Permit # \_\_\_\_\_ City of \_\_\_\_\_ BUILDING PERMIT APPLICATION Fee \_\_\_\_\_ Zone \_\_\_\_\_ Map # \_\_\_\_\_ Lot# \_\_\_\_\_

BUILDING PERMIT REPORT

ADDRESS: 88 Mabel ST.

REASON FOR PERMIT: To construct a 10'x30' porch

PLOT PLAN

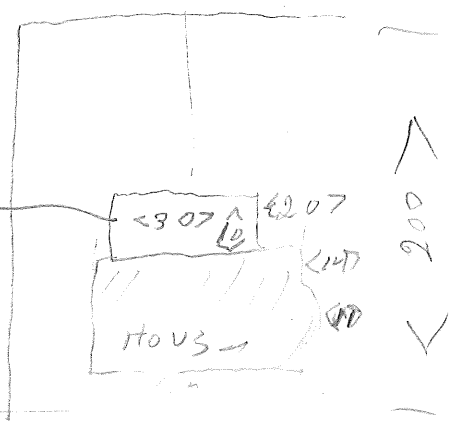
- \* 12. Rear setback requirement 25'
- \* 13. side setback requirement 14'
- \* 14. max. lot coverage 25%
- \* 15. 10" concrete piers will be a minimum of 4' below grade resting and anchored to footing
